Project Address: 1411 S. Potomac St. Unit # 400 Zip code: \_\_\_\_\_  
Project Name: Colorado Orthopedic Consultants  
Contractor Company Name: TBD Phone: \_\_\_\_\_ Fax: \_\_\_\_\_  
Contact Person: \_\_\_\_\_ Phone: \_\_\_\_\_  
Email: \_\_\_\_\_ Fax: \_\_\_\_\_

Tenant Improvement Build-out Colorado  
Orthopedic Consultant

RSN: 619637  
Permit #: 2011558118

Cover  
Sheet

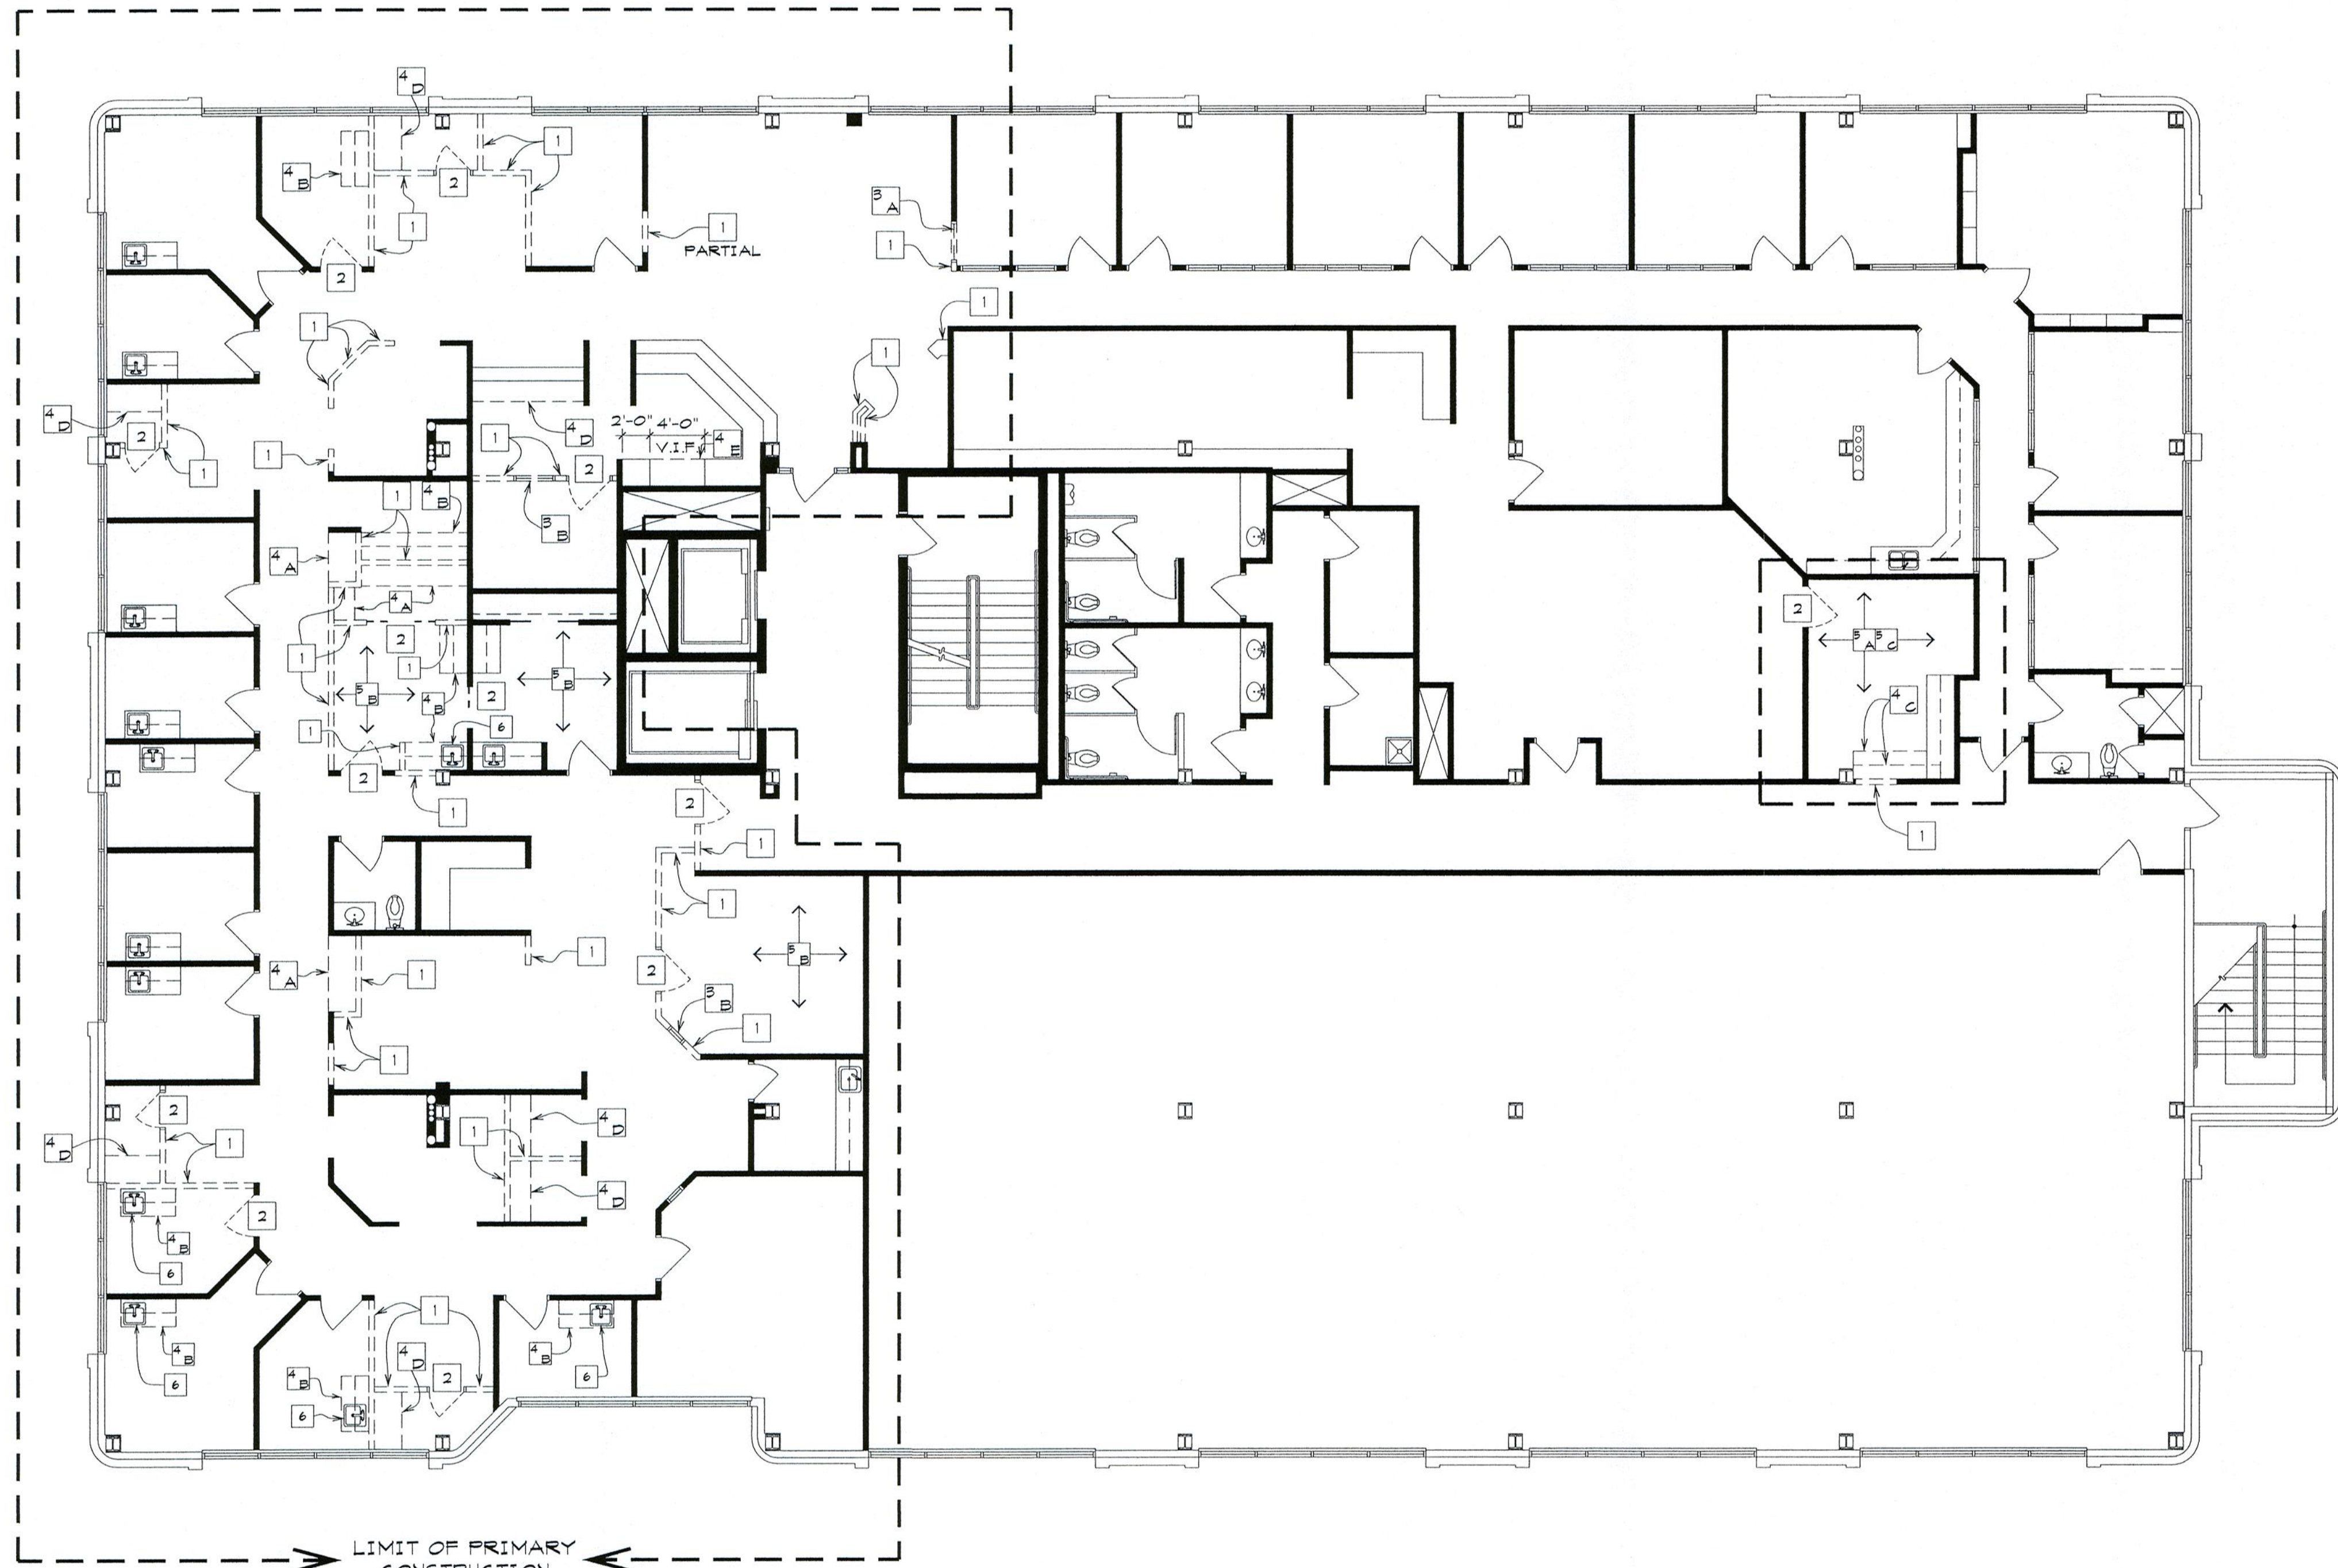
Change Building Co From UBC to IBC  
II A 3011

Demolition  
Plan  
**TA-2**

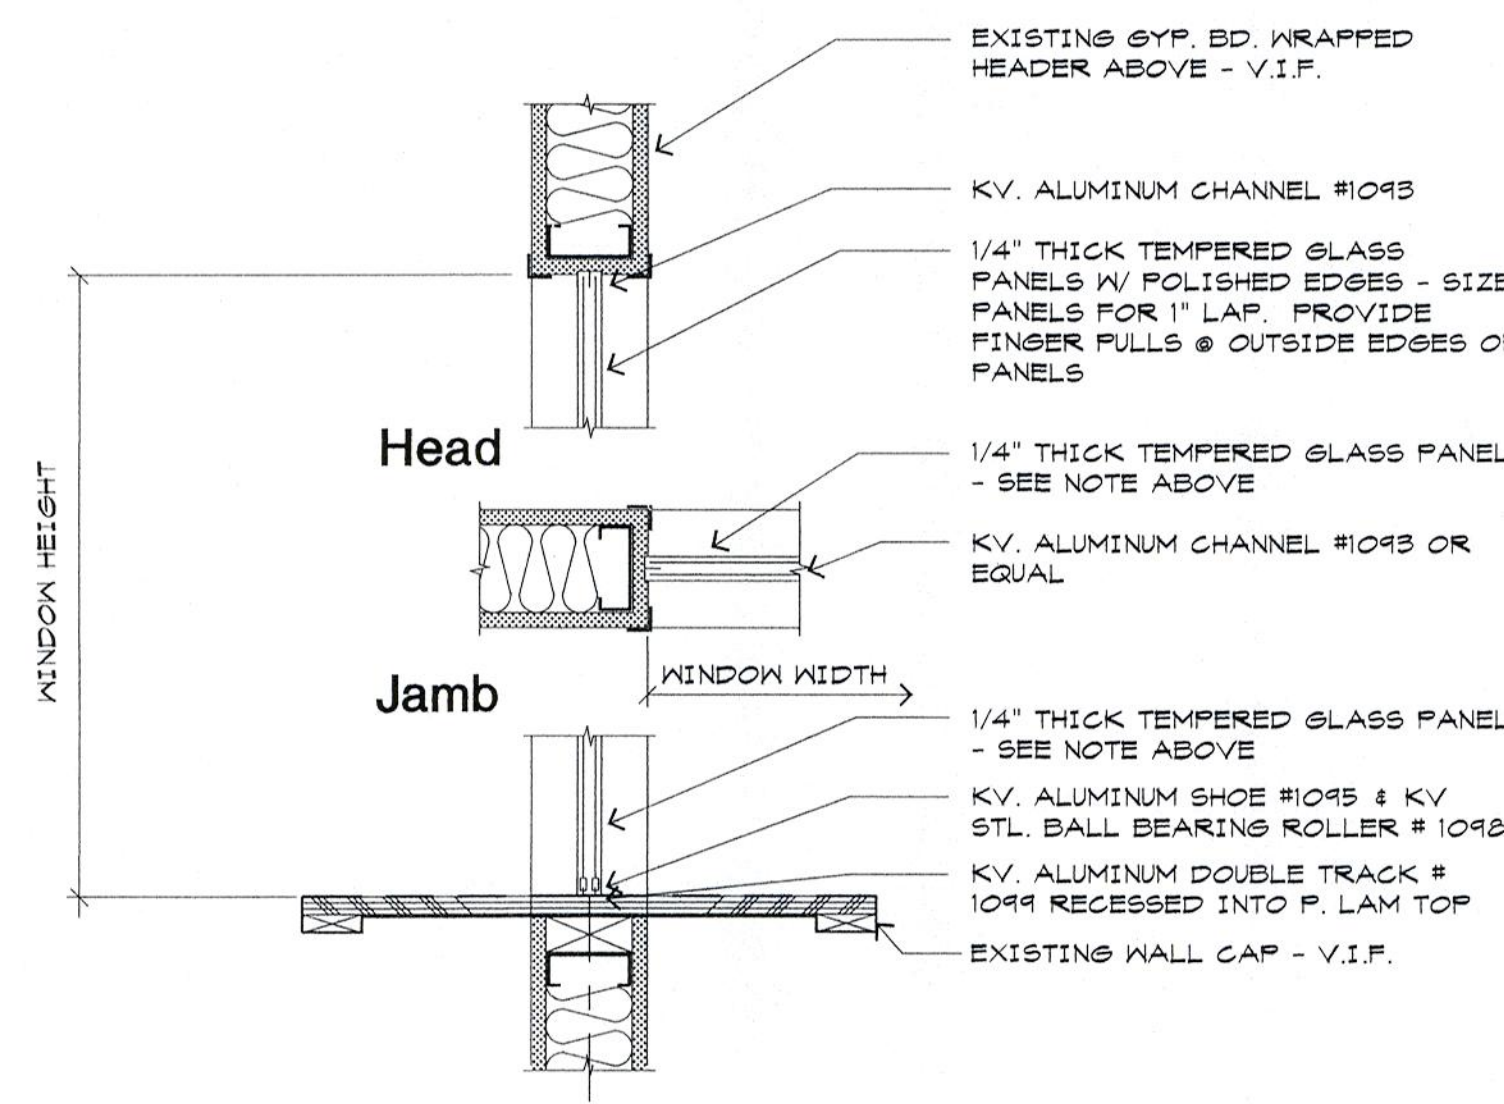
Provide a tactile sign saying "EXIT" at each egress stairway, exit passageway or exit discharge per 2009 IBC 1011.3 and 2003 ANSI A117.1
